DSO9254A-03

S E R V I C E N O T E

DSO9254A - 2.5GHz Digital Signal Oscilloscope

Repair for Windows "Power surge on hub" message

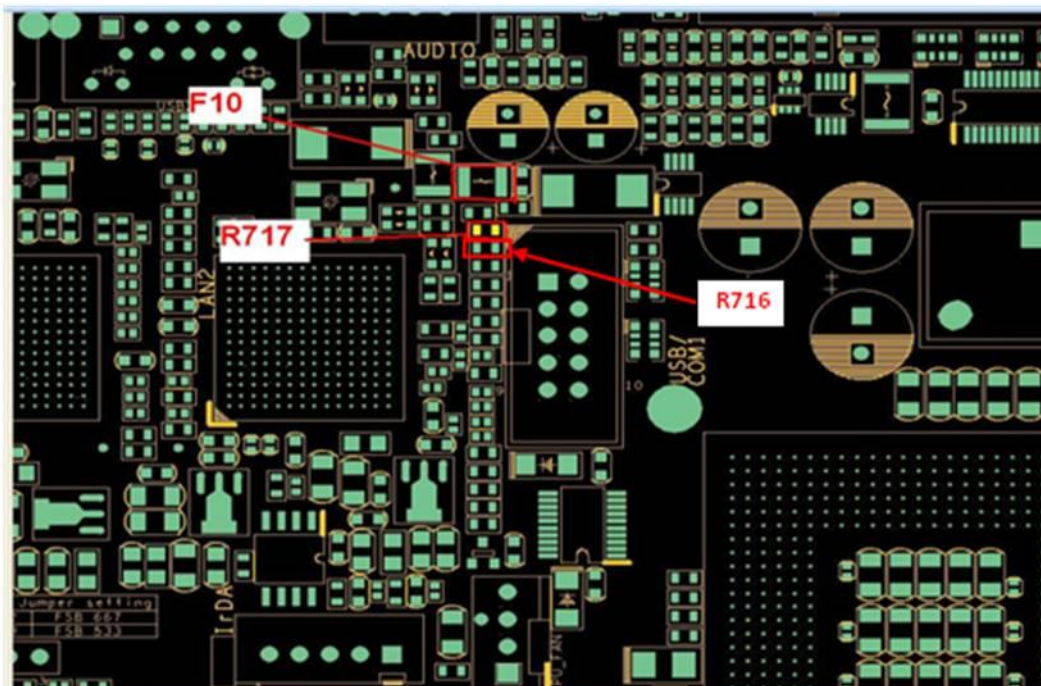
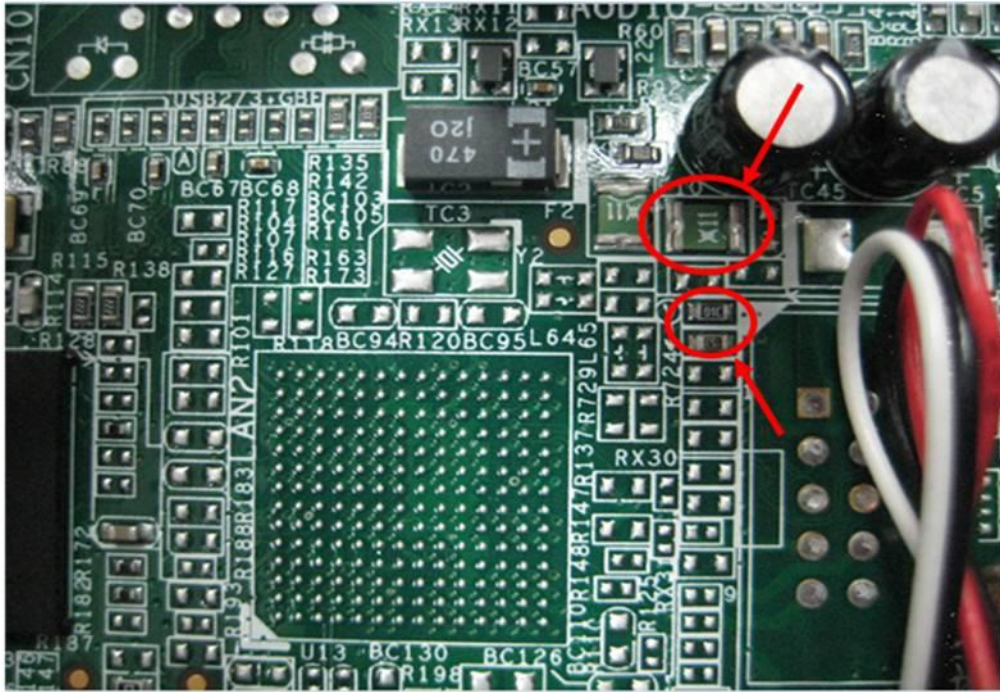
1. Refer to the service manual to remove the motherboard from the scope.
2. Install the three components from the upgrade kit on the motherboard. Refer to the below drawing and the drawing on the next page for component locations. The 0960-2789 motherboard is RoHS compliant and the below three components are also RoHS compliant. You should use a RoHS soldering station and RoHS solder techniques when possible.

F10 – 0837-3854 Thermistor

R717 – 0699-7654 10K Resistor

R716 – 0699-5789 15K resistor
